TECHNICAL SERVICE BULLETIN

Title: Cab Tilt Velocity Fuse 2-Door Cab

Date: August 28, 2019

Vehicles: *KME Custom Pumpers*

Figure 1 Inside Front Cab Wheel Well

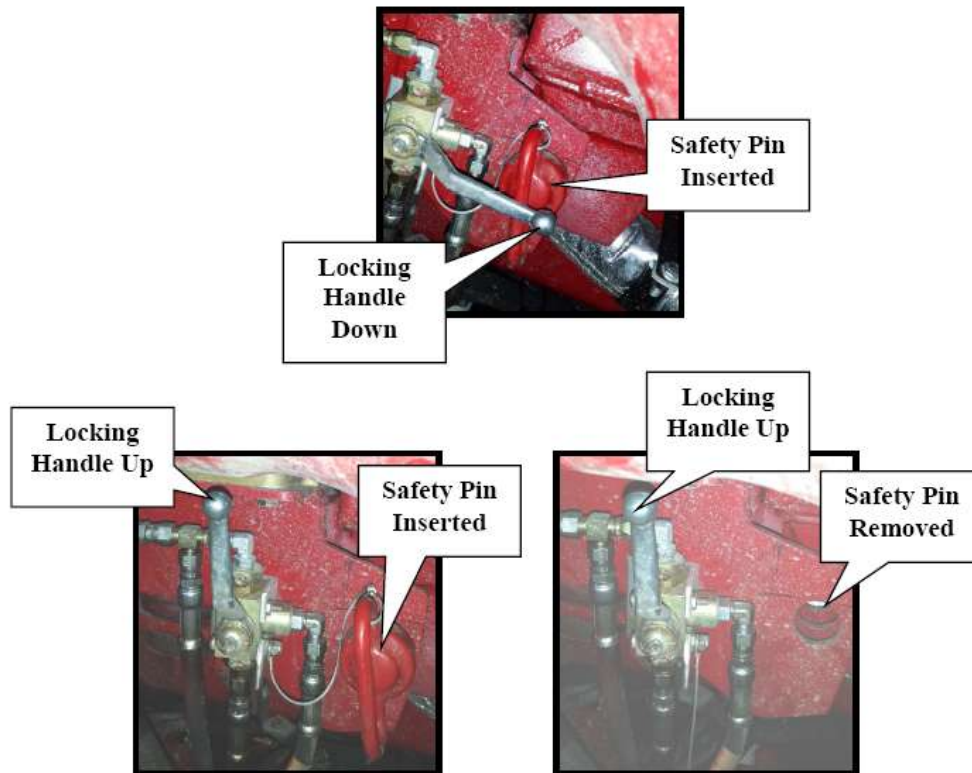
1. Ensure all loose equipment inside the front of the cab is secure. Follow previous warnings.
2. Close front doors of the cab, remove guide posts from bumper, and check the front discharge and swivel are clear before fully tilting.
3. Remove the Safety Pin from both sides of the cab. See picture above.

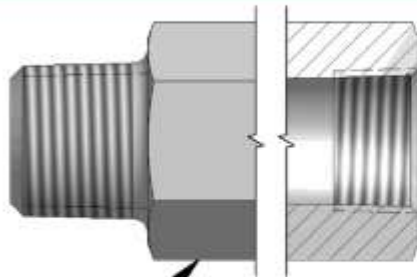
NPTF THREAD SIZE	TURNS PAST FINGER TIGHT	HEX (TYPICAL) (in.)		
		MALE → MALE	FEMALE → FEMALE	MALE ↔ FEMALE
1/8 – 27	2 – 3	0.438	0.625	0.625
1/4 – 18	2 – 3	0.625	0.750	0.750
3/8 – 18	2 – 3	0.750	0.875	0.875
1/2 – 14	2 – 2.5	0.875	1.125	1.125
3/4 – 14	2 – 2.5	1.125	1.375	1.375
1 – 11 1/2	1.5 – 2.5	1.375	1.625	1.625
1 1/4 – 11 1/2	1.5 – 2.5	1.750	2.000	2.000
1 1/2 – 11 1/2	1.5 – 2.5	2.000	2.375	2.375
